# Strategic & Corporate Committee

**Item No:** R1 Recommendation to Council  
**Subject:** **PUBLIC EXHIBITION AND APPROVAL OF THE DRAFT WOOLLAHRA DEVELOPMENT CONTROL PLAN 2014**  
**Author:** Anne White – Acting Team Leader Strategic Planning  
**File No:** SC2424 and 1078.G Draft Woollahra Development Control Plan 2014  
**Reason for Report:** To respond to the submissions and proposed amendments put forward at the Urban Planning Committee Meeting on 13 April 2015.  
To obtain Council's decision to approve Woollahra Development Control Plan 2015.

**ANNEXURE 1: SUMMARY OF ISSUES RAISED AT THE UPC MEETING OF 13 APRIL 2015, A PLANNING RESPONSE AND RECOMMENDED AMENDMENTS**

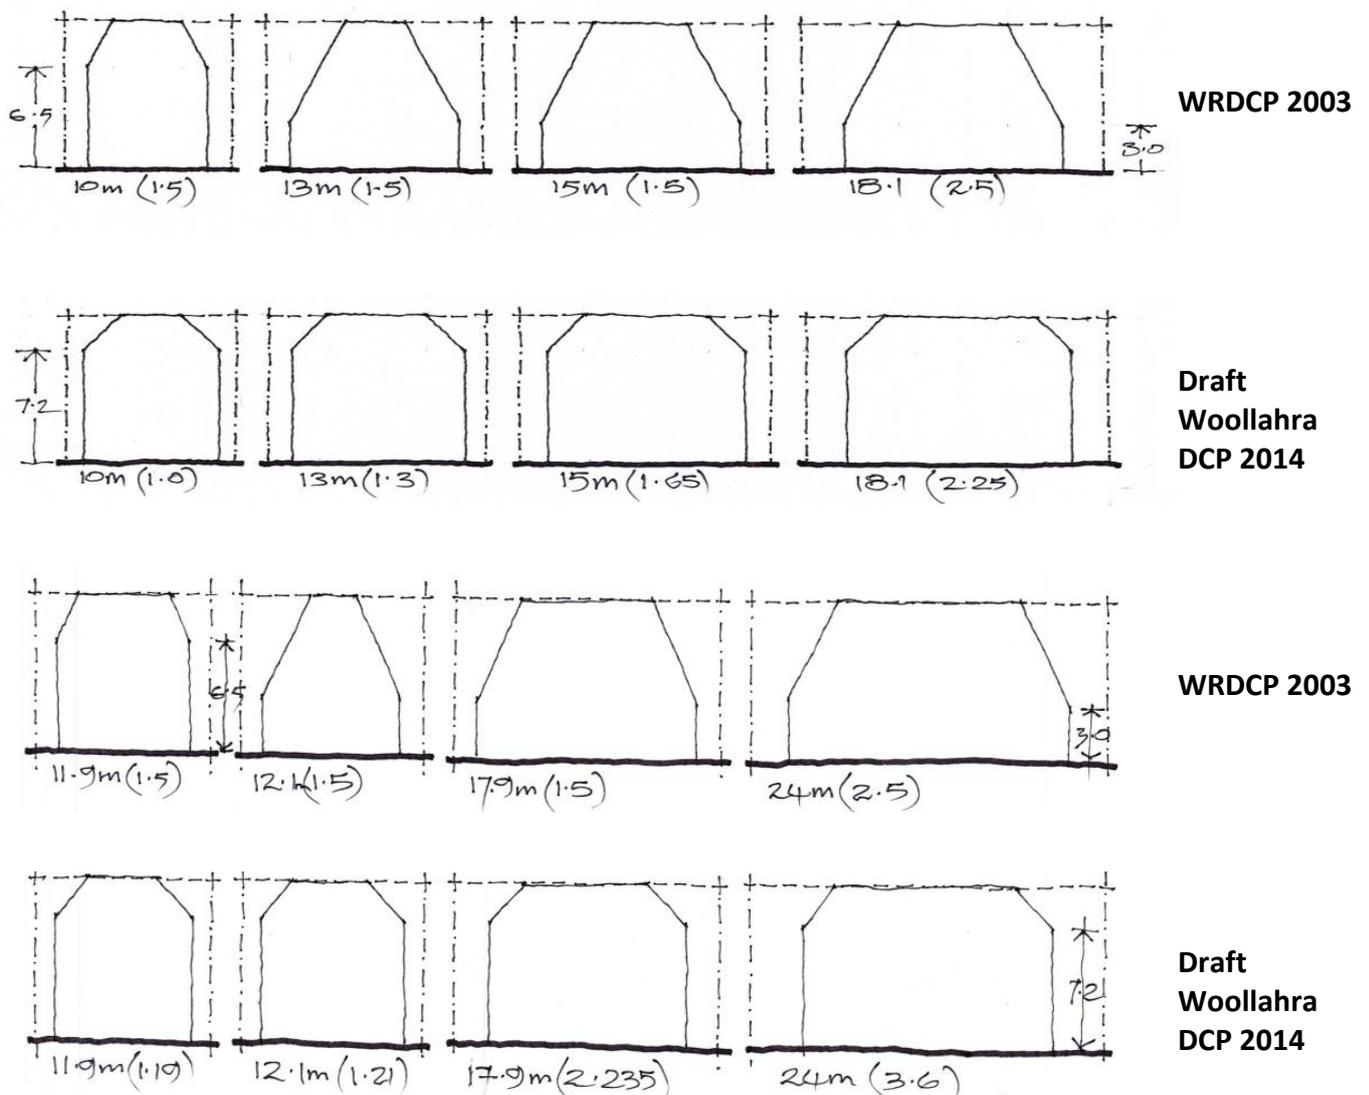
**Issue 2**                      **Increase side setback controls for residential development**

A comparison of the side setback controls between the Woollahra Residential DCP 2003 and Draft Woollahra DCP 2014 is provided below. The comparison diagrams below (and Table 1 containing all the setbacks) illustrate comparative setbacks for the Manning Road precinct in Double Bay.

This comparison illustrates that the proposed side setbacks at ground level are both less and greater than those in the WRDCP 2003. This is because we are proposing to replace the current side setback controls with a side setback sliding scale which is a percentage of site width. To fully understand the effect of the side setback on the whole building, the setbacks at ground, first, second and roof levels all need to be considered, and not just the side setbacks at 7.2m above ground level (as identified in the submission from Mr Young).

The following diagrams illustrate and compare the side setback controls of WRDCP 2003 and Draft WDCP 2014, as they apply to residential parcels of various widths.

Note: these images show the building envelope and **not** the built form

It is important to note that the building is only able to occupy a portion of the building envelope, and the diagrams above are not the actual building. Accordingly, the side setbacks identified are a “minimum”, which will need to be increased based on the particular site conditions. For example, a house must be positioned within the envelope to take into account:
